These are each potential shrubs, to be used as hedging on this site, named within 2020-93954_+Proposed+Site++Block+Layout_957506.PDF.

The applicant's latest submission allows for shrubs and small trees: see below (taken from 2020-93954_+Proposed+Site++Block+Layout_957469.PDF), where some are circled in red:

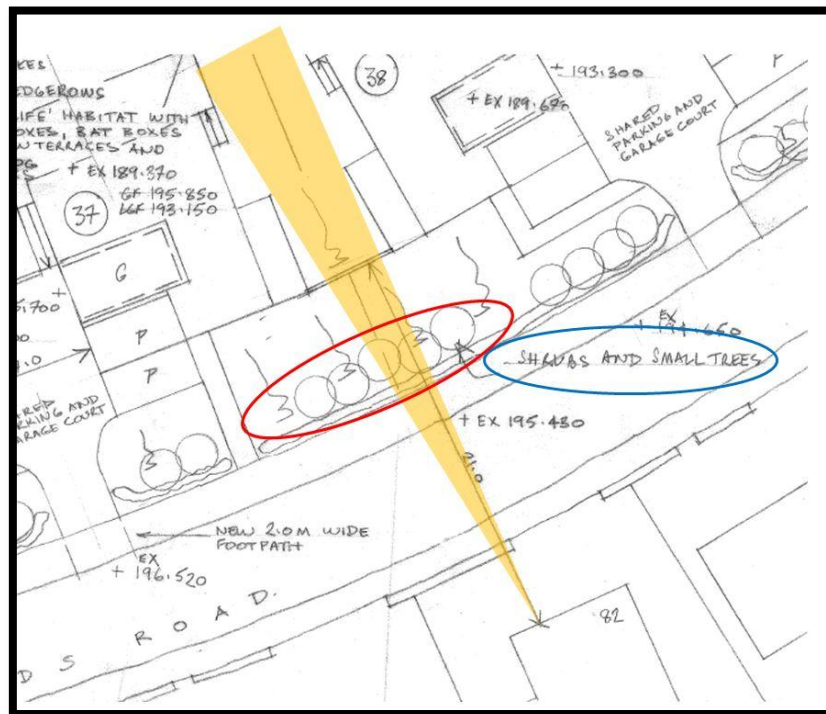
You will note, there is very little (if any) gap between adjacent shrubs/trees.

The impact of this is that access to sufficient nutrients appears to have been given little (if any) thought.

The image below shows the same shrubs and small trees, but, this time, showing where an existing neighbour's view, through the two proposed dwellings, would be.

Considering the possible height, shrubs and small trees can achieve, their placement is at odds with the gaps, between the associated dwellings, which are supposedly to provide (limited) views past those dwellings (for neighbouring existing residents).

Leaving gaps that are then obscured can hardly be described as beneficial for neighbouring existing residents.
